## BULLETIN NO. 2

### 491/20167.SDW - PHASE 500: CENTER FOR FORENSIC PSYCHIATRY- CREATE KITCHEN SALINE, MICHIGAN

WTA Project No. 2021094  
MAY 14, 2025

SHEET NUMBER  
M2.00

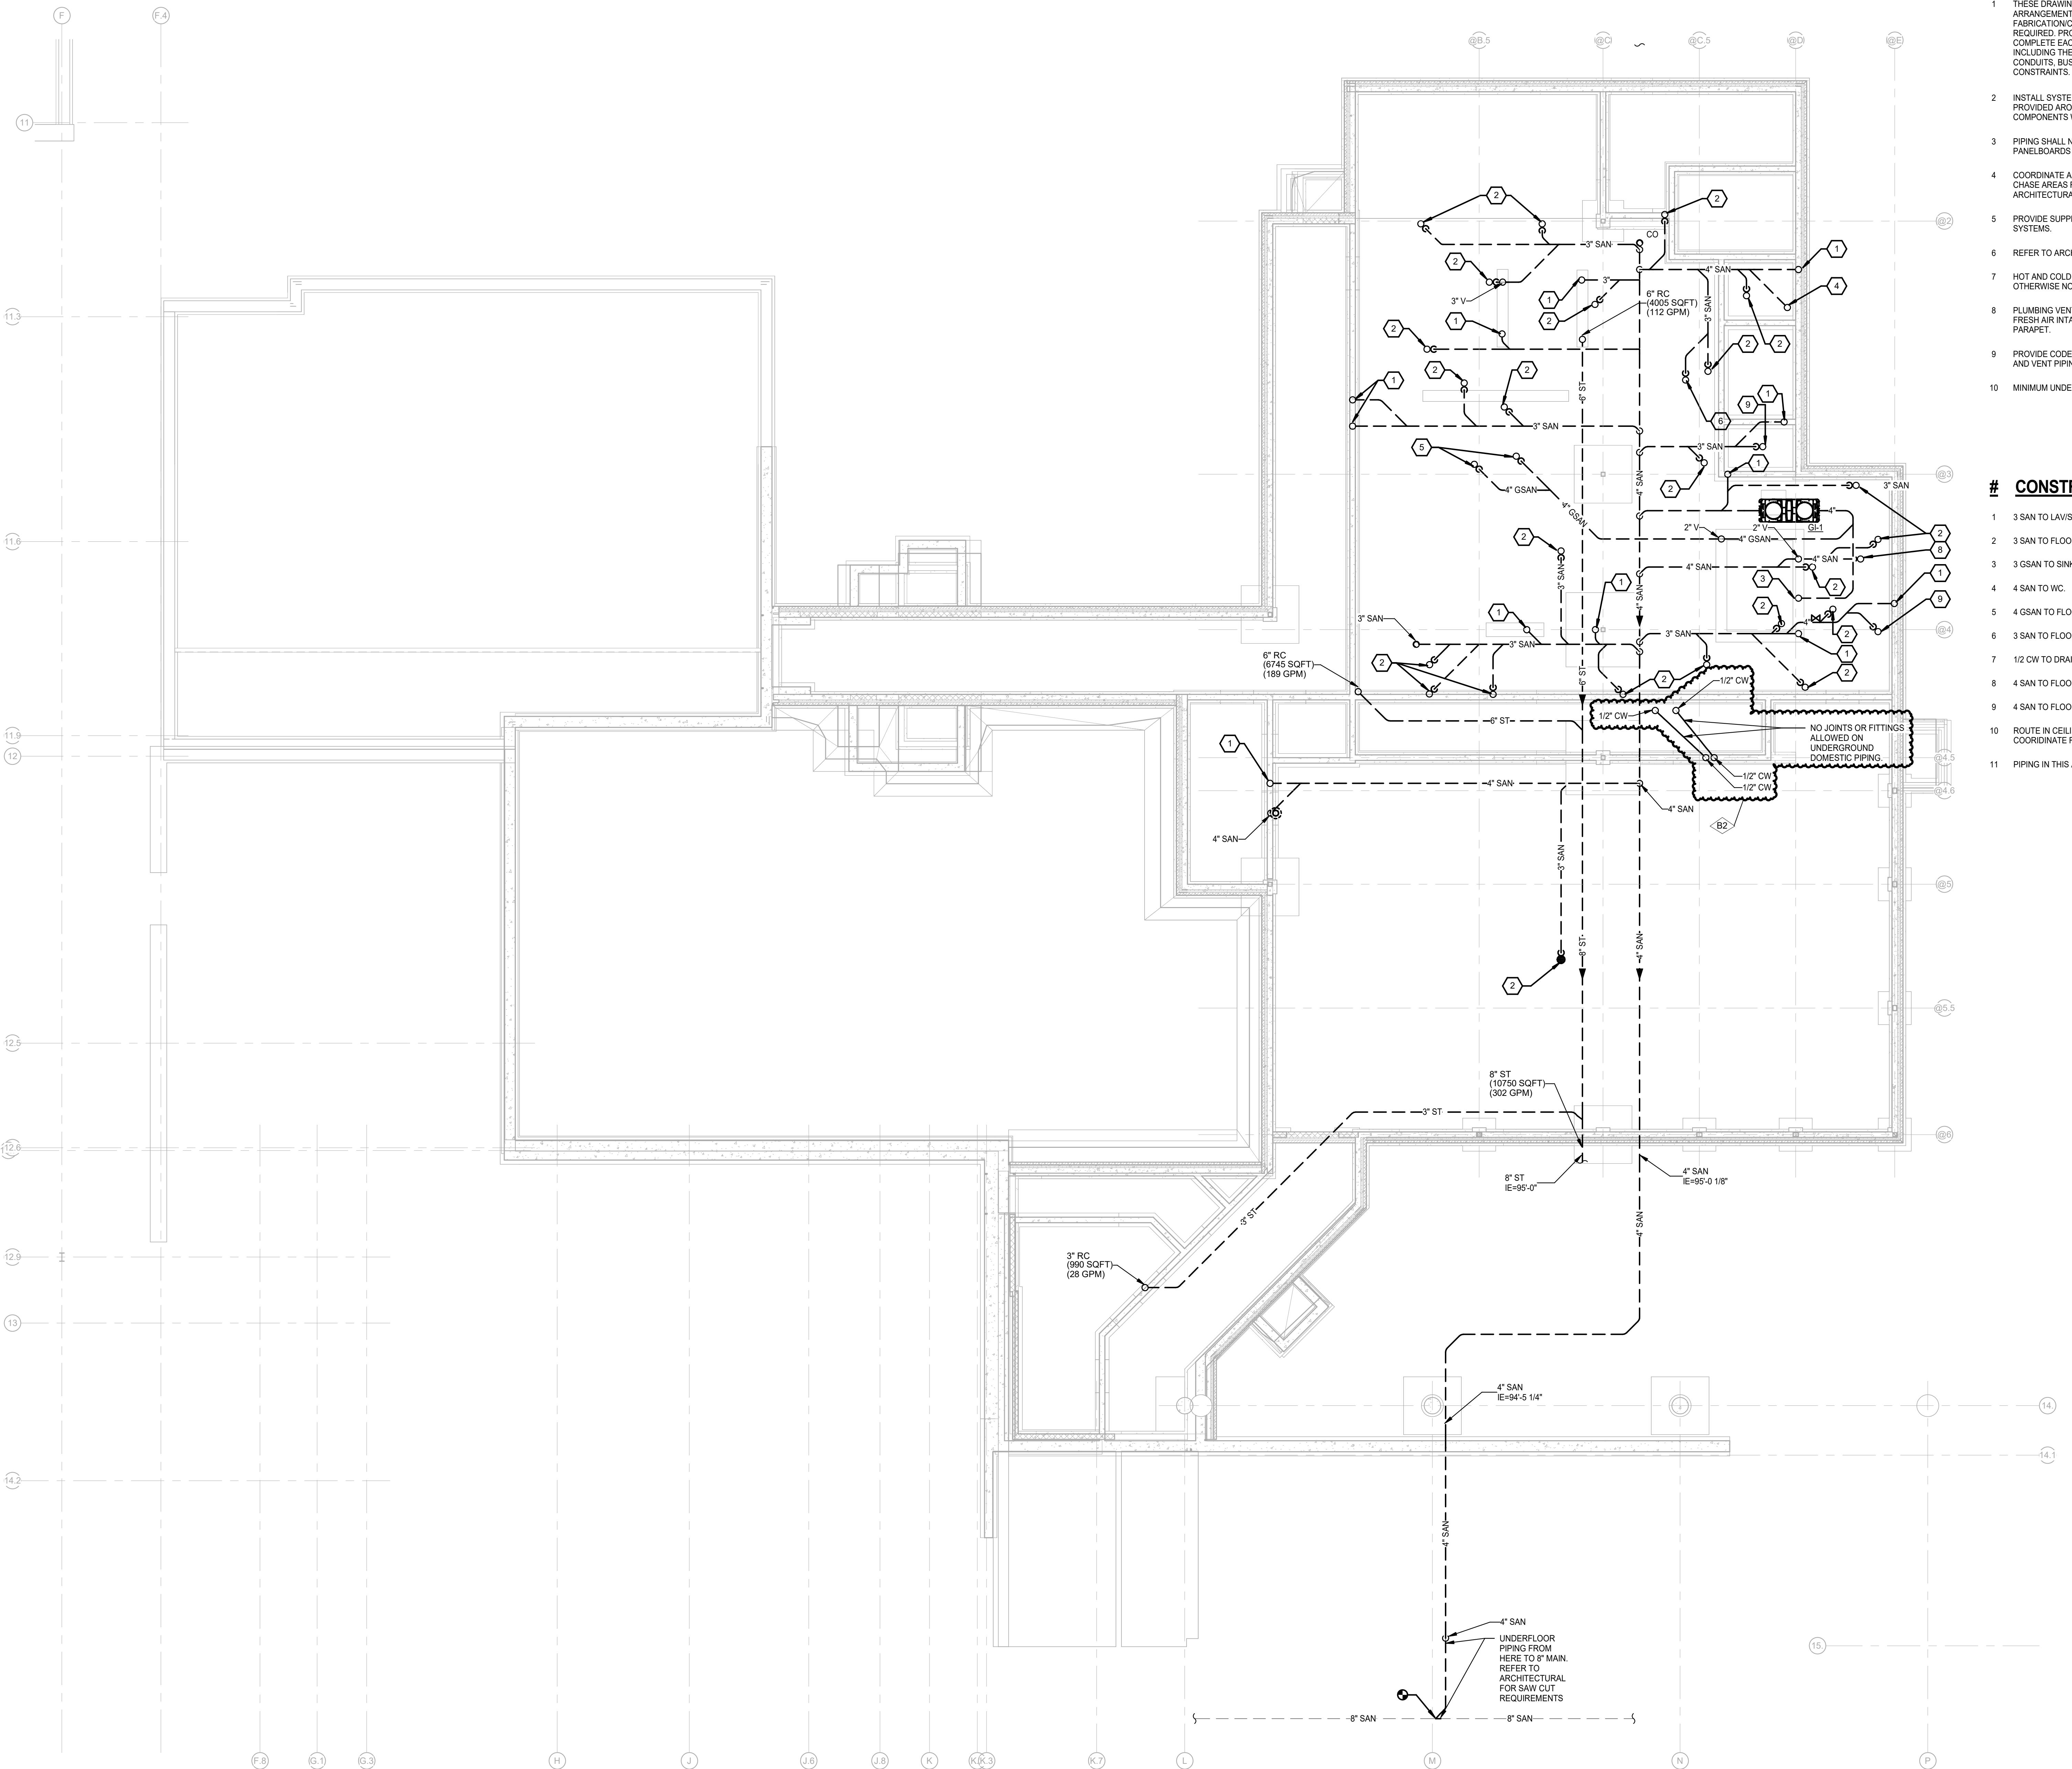
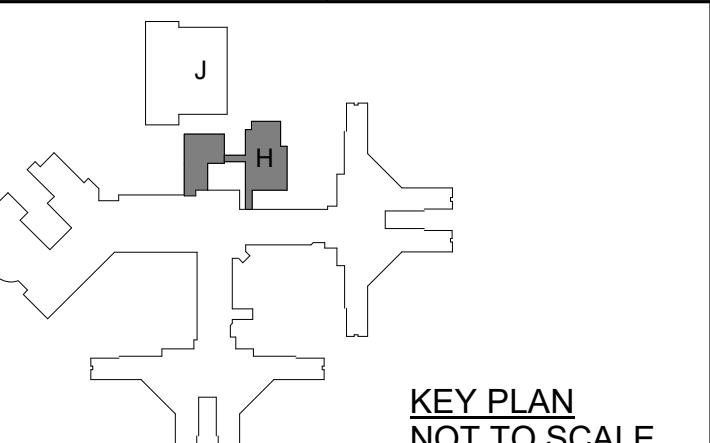
Item M1      Reference Sheet M2.00 (**Re-Issued**)  
A. Revised CW to underground to serve fixtures as indicated.

PROJECT NUMBER  
2021094  
SHEET NUMBER  
M5.01  
C.R.EVIT LOCAL FILES\2021\402\MEP\_Forensic\_Psych\_Create\Kitchen\402\Kitchen\402.dwg  
4:08:2025 2:41:03 PM  
CHECKED BY  
WEK

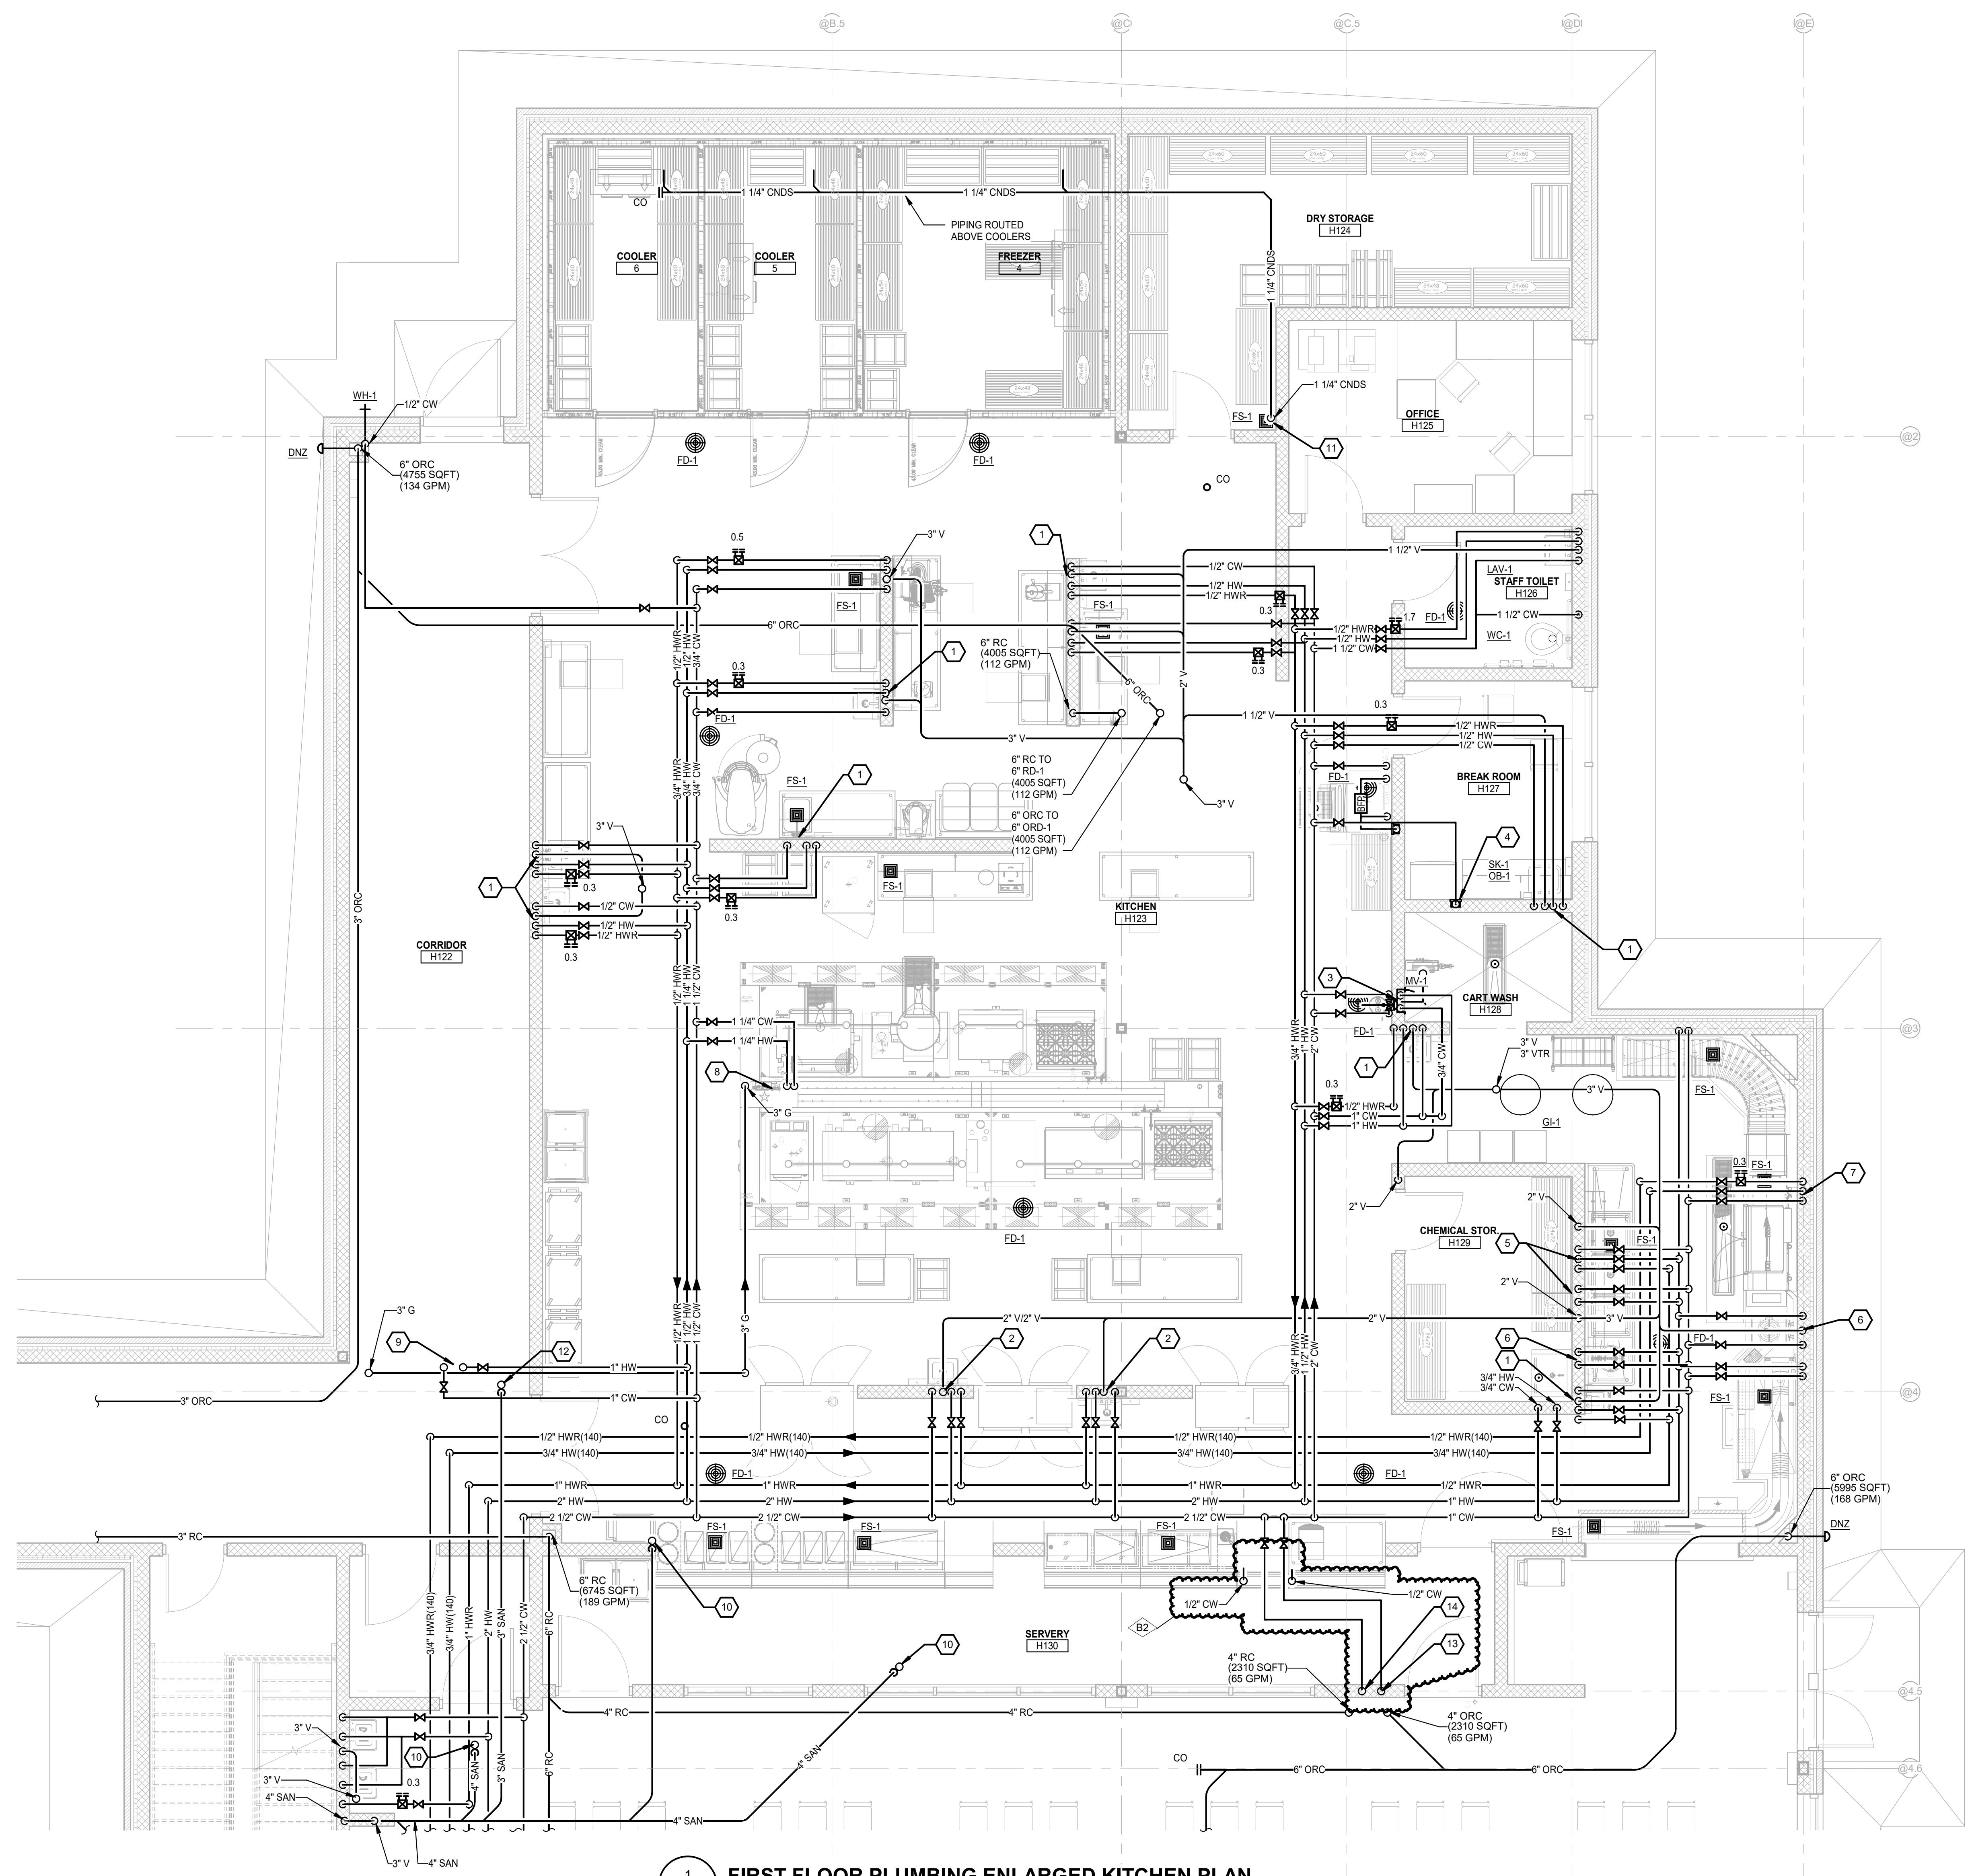
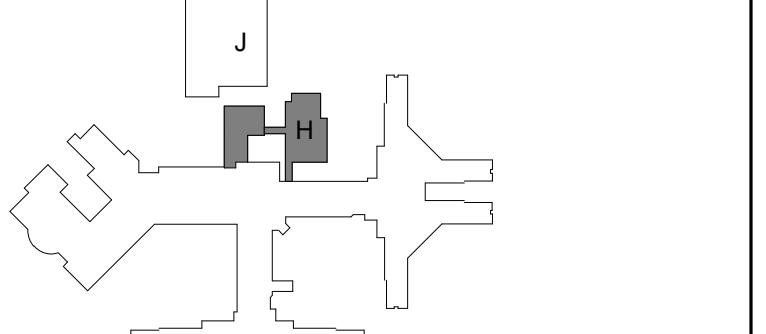
Item M2      Reference Sheet M5.01 (**Re-Issued**)  
A. Revised CW to route underground to serve fixtures as indicated.  
B. Added CONSTRUCTION KEY NOTES 13 AND 14 as indicated.
